AGENDA

SANTA CLARA/SANTA CRUZ COUNTIES AIRPORT/COMMUNITY ROUNDTABLE

Fourteenth Regular Meeting of the Roundtable

**October 28, 2020
1:00 – 4:00 PM PDT**

BDEGA usage analysis

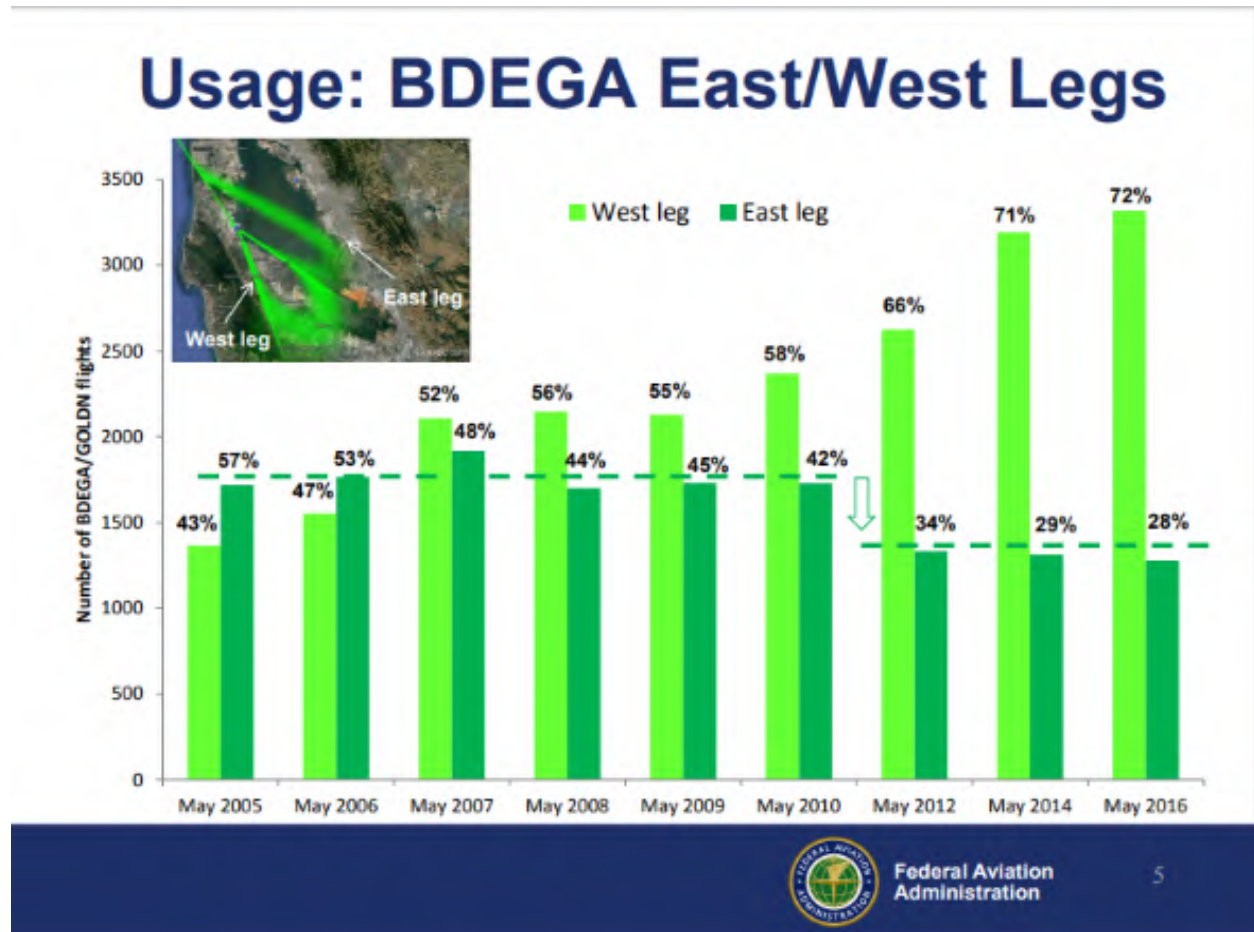
Given the limited improvement observed on the percentage use of BDEGA-east, we would therefore like the FAA to address the following BDEGA questions:

- In particular, please specify whether NIITE/HUSSH departures or OAK departures to FFOIL with transition to YYUNG conflict with BDEGA-east arrivals.
 - Please provide specific reasons why BDEGA-east was used only 40% of the time in May 2020, but 57% of the time in May 2005 when traffic volume was about three times higher.

San Francisco 2018 flight tracks

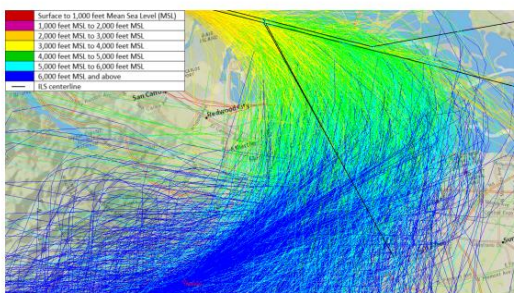
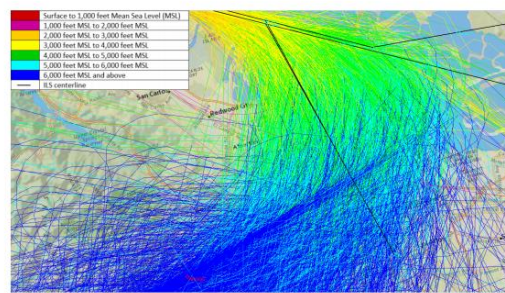
As shown by the [FAA data presented on Feb 26, 2020](#),⁸ Oceanic arrivals increased by 35.5% between 2018 and 2019 based on May-August data for each year. The FAA statement that “**Any increase** [emphasis added] in operations in Oceanic arrivals to the Bay Area would result from factors, such as market conditions, that would occur regardless of the arrival procedures in place” implies that Oceanic arrivals increased because of market demand and not as a result of converting TA and non-TA arrivals into the PIRAT RNAV/OPD procedure. This FAA statement appears **subjective** and **not substantiated** by an analysis of increased demand at both airports.

1 San Francisco (SFO) OFFSHORE 1 departure Background

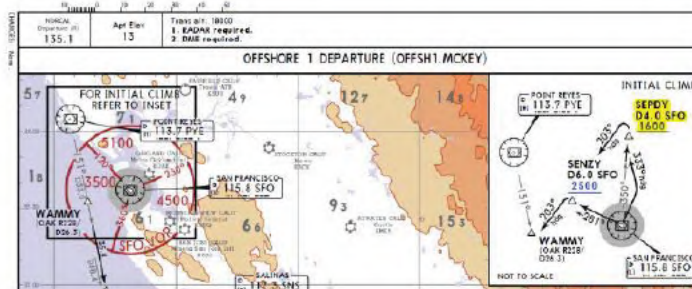
Multiple FSAP reports have indicated FMC anomalies resulting in an early turn prior to SEPDY when assigned runway 1L/R and the OFFSHORE 1 DEPARTURE (OFFSH1.MCKEY) with LNAV engaged. United requested GE assist in the investigation of the FMC anomalies. GE was able to reproduce an early turn event just prior to SEPDY on heavy B737 aircraft in certain wind conditions.

RWY	INITIAL CLIMB	TOP ALTITUDE
1L/R	Climbing LEFT turn heading 353° to intercept SFO R350 to cross SEPDY at or above 1600	Assigned by ATC
28L/R	Climb on SFO R281 to cross SENZY at or above 2500.	
ROUTING		
Climbing LEFT turn heading 203° to intercept PVE R151 to cross SEGUL at or above 16000, then on PVE R151 to cross CYPRS at or above FL220. Then on MQO R295 to MCKEY, then on assigned transition. MAINTAIN FL220. EXPECT filed altitude 10 minutes after departure.

Figure C2. BOS 4L/R Arrival Dispersion Flight Tracks

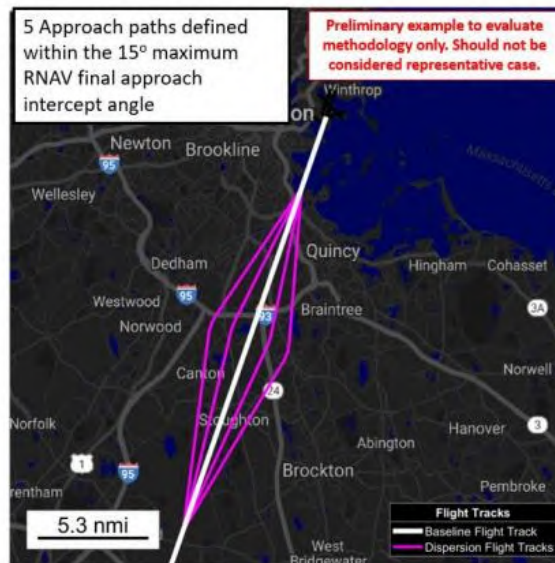
- Arrivals Dispersion (page 97): the authors illustrated the concept in figure C2 but did not go further because, according to them, it would lead to shifting noise from one community to another.

FIGURE 1. Big Sur RNAV STAR Notional Design: Descent Gradient Criteria

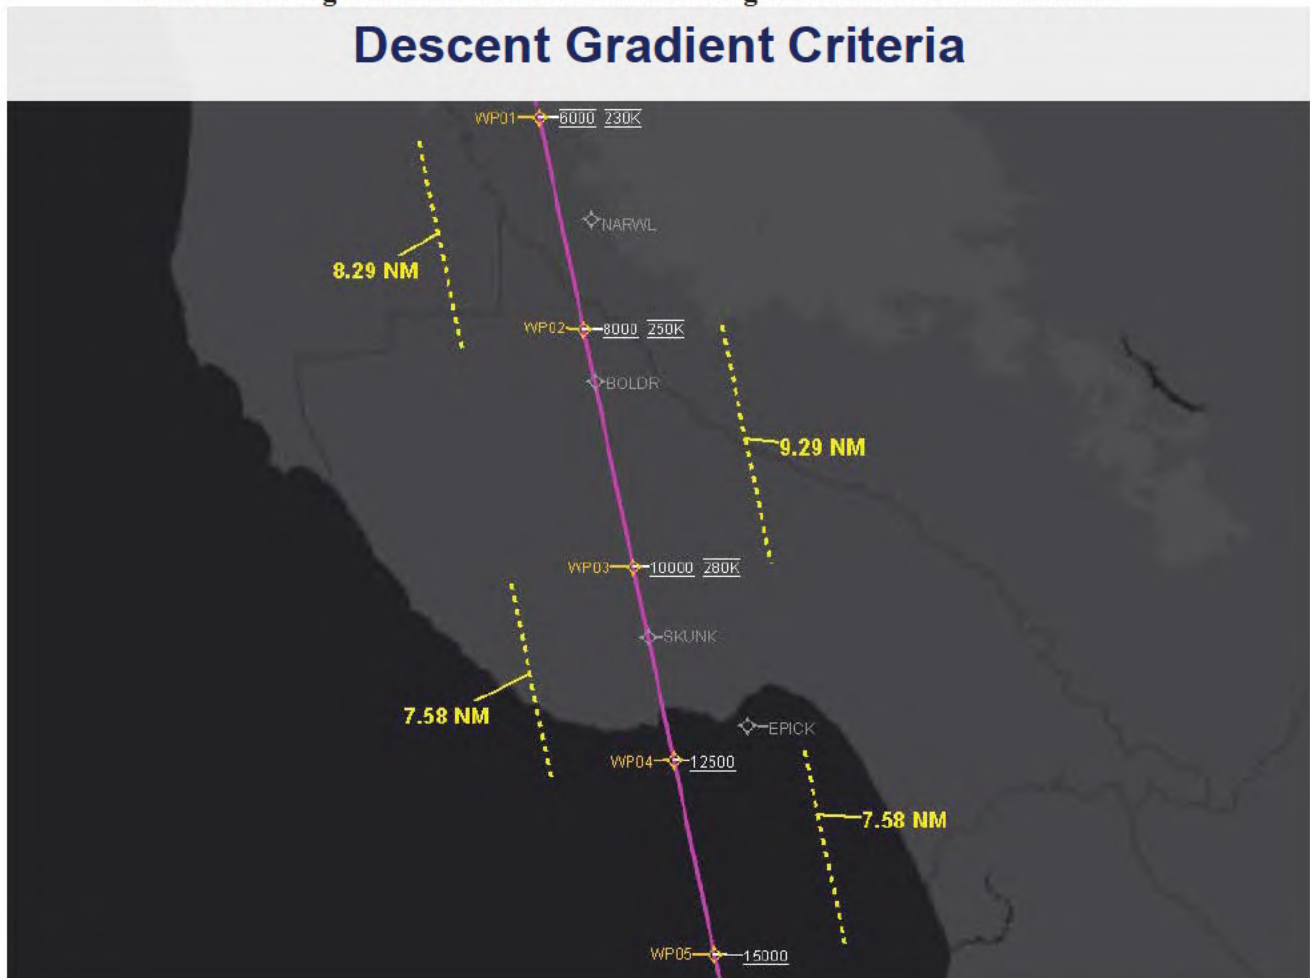
2. JH presented a notional RNAV STAR design demonstrating the location of speed and altitude restrictions overlying the BSR lateral track that would be required to comply with design criteria. Also presented were illustrations comparing the Select Committee recommendations and the resultant design challenges for FWG consideration (See **Figure 1**).

FIGURE 2. Big Sur RNAV STAR Notional Design

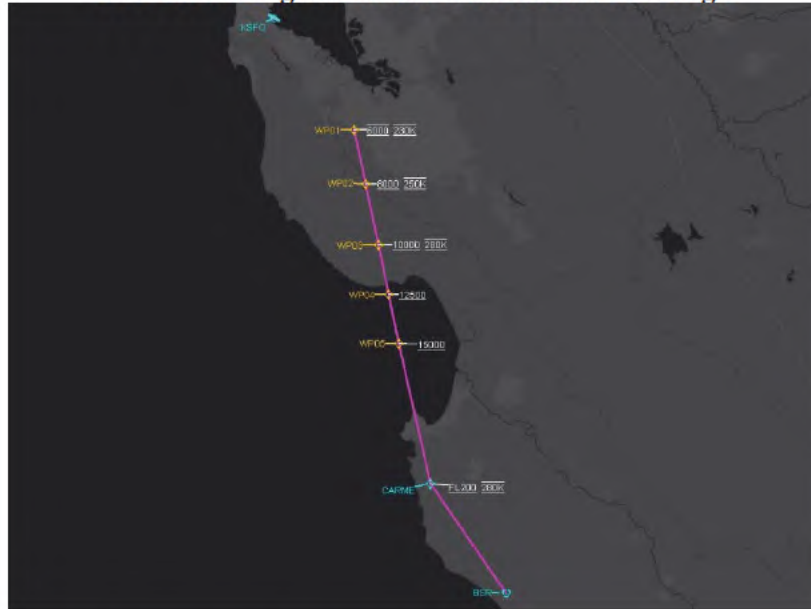
3. JH proposed a methodology as to how the FWG should proceed for analyzing and discussing the notional design (See **Figure 2**.), suggesting starting from WP01 and working southward to the BSR VOR.

FIGURE 4. WP02 Segment

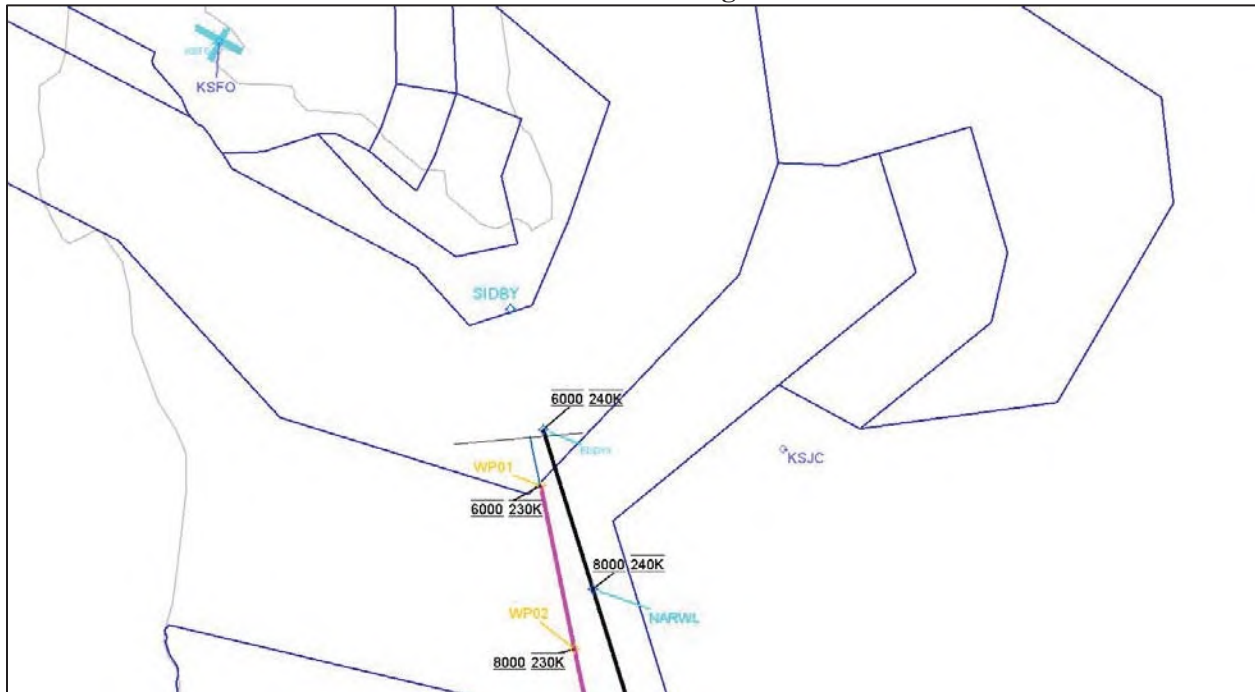
- b. JH queried the FWG as to feasibility of the WP02 segment (See **Figure 4**.)

- (1) The FWG experimented with moving WP02 2NM to the north, At Or Above (AOA) 8,000'. The Targets Operator (TO) adjusted the notional design and the relocated WP02, still meeting design criteria.

FIGURE 5. WP03 Segment

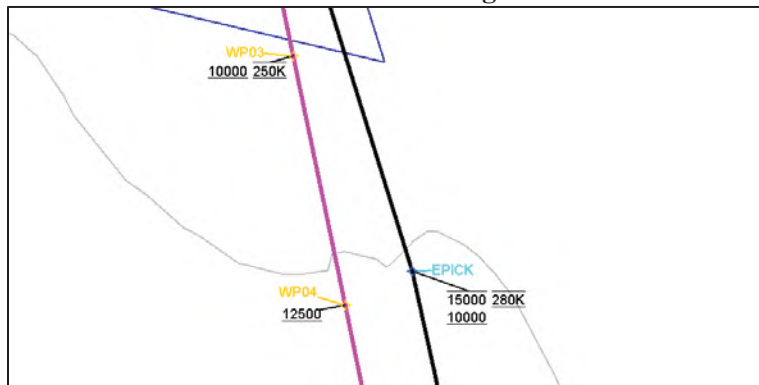
- c. JH queried the FWG as to feasibility of the WP03 segment (See **Figure 5**.)
 - (1) The TO also moved WP03 to a location that criteria allowed 10,000' @ 250KTS. This is the criteria changeover point from 318'/NM to 330'/NM (descent gradient criteria)
- d. The TO created an additional waypoint (WP215) on the procedure at the 11,000' mark, to allow for TARGETS rounding errors
 - (a) (Note: WP215 was later removed as it was deemed unnecessary for criteria)

Figure 7. TARGETS Simulation Results near WP04

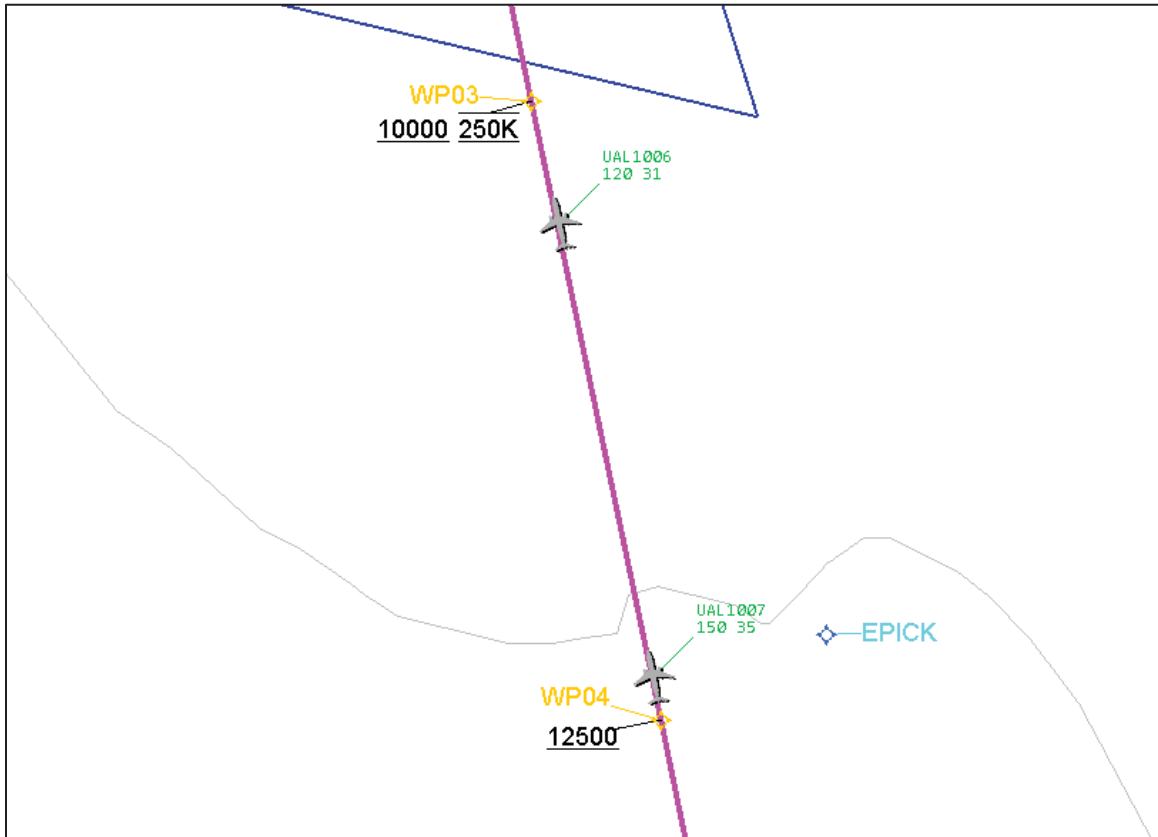
- e. JH queried the FWG as to feasibility of the WP04 segment (See **Figure 6.**)
 - (1) The FWG experimented with where 12,500' @ 280KTS would be located (WP04) on the procedure and if it would resemble the Select Committee recommendation (over Monterey Bay)
 - (a) WP04's new location is approximately 2.2NM from the shoreline
 - (2) The TO performed a TARGETS flight simulation to demonstrate approximate aircraft altitudes near the 12,500' restriction at WP04 (based on average B737 performance with no winds aloft).

- b. TO performed a TARGETS Flight Evaluation to demonstrate average aircraft performance when approach the AoA12,500' restriction at WP04. (See **Figure 7.**)

FIGURE 8. WP04 - ANJEE Segment

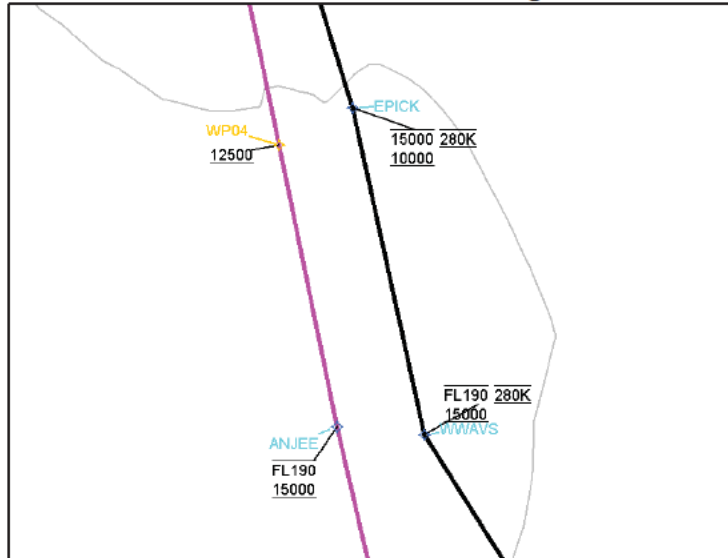
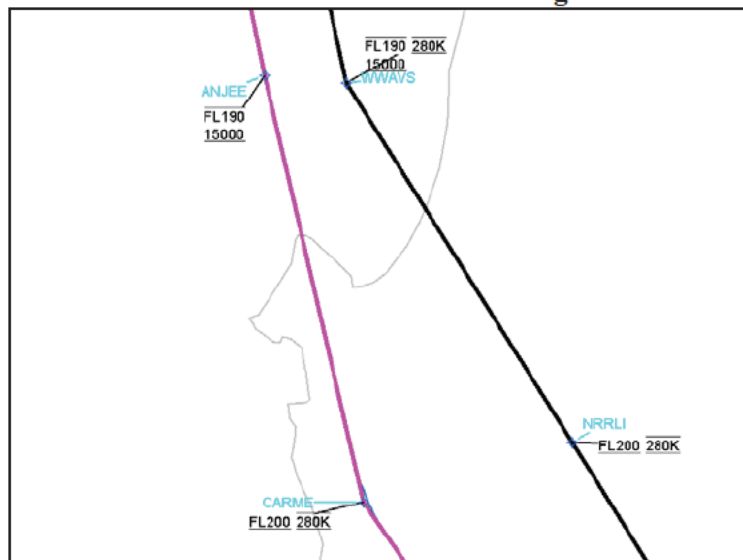
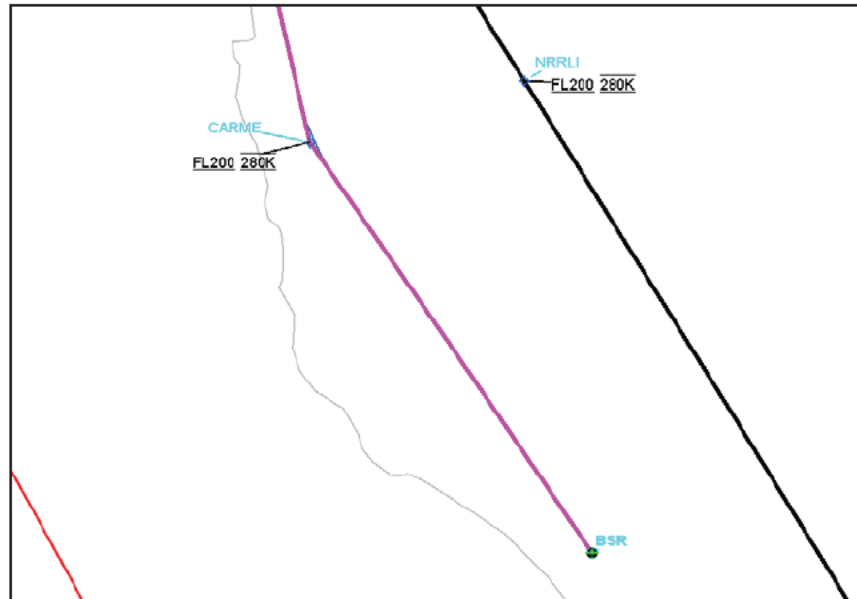
- c. JH queried the FWG as to feasibility of the WP05 segment and remaining points beyond (See **Figures 8-10.**)
- (1) WP05 required relocation (south) to allow the procedure to conform to descent gradient criteria.
